General response authors

A three-dimensional palaeohydrogeological reconstruction of the groundwater salinity distribution in the Nile Delta Aquifer

Figure A2: Total annual abstraction used as model input for the last 30 years of the simulation. This period has stress periods of 5 years.

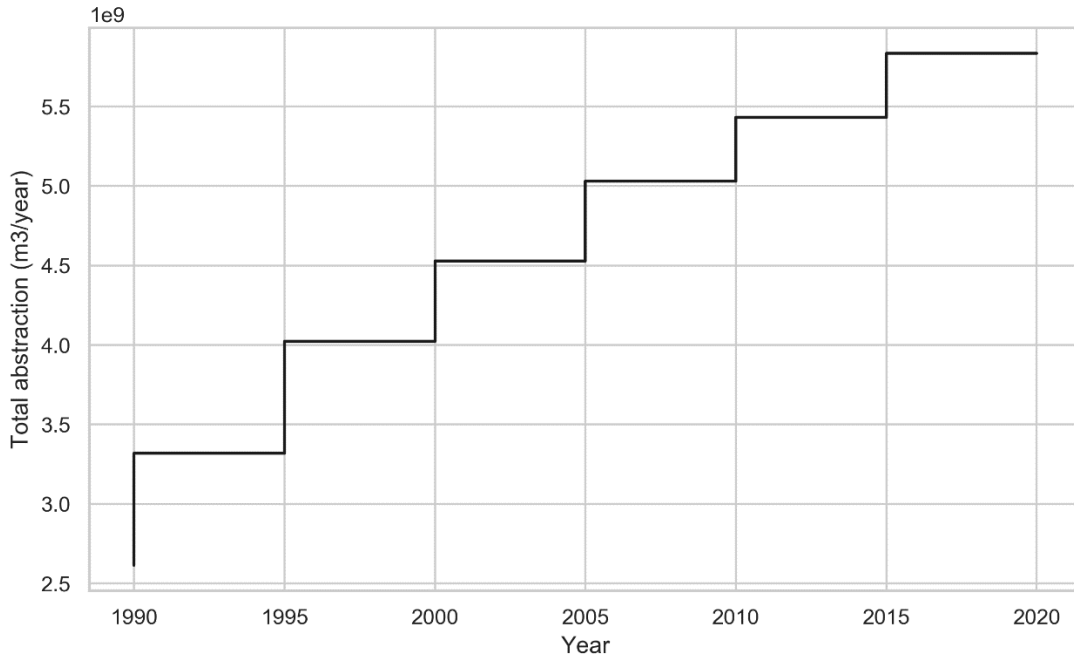
P9L14: “including extraction wells (locations and rates)”

Provide some key figures here, for example the total annual abstraction and how it has increased over time

We have added a figure to the appendix (Fig. A2), since the focus of this paper is on the palaeohydrogeology and not as much on the human influence.
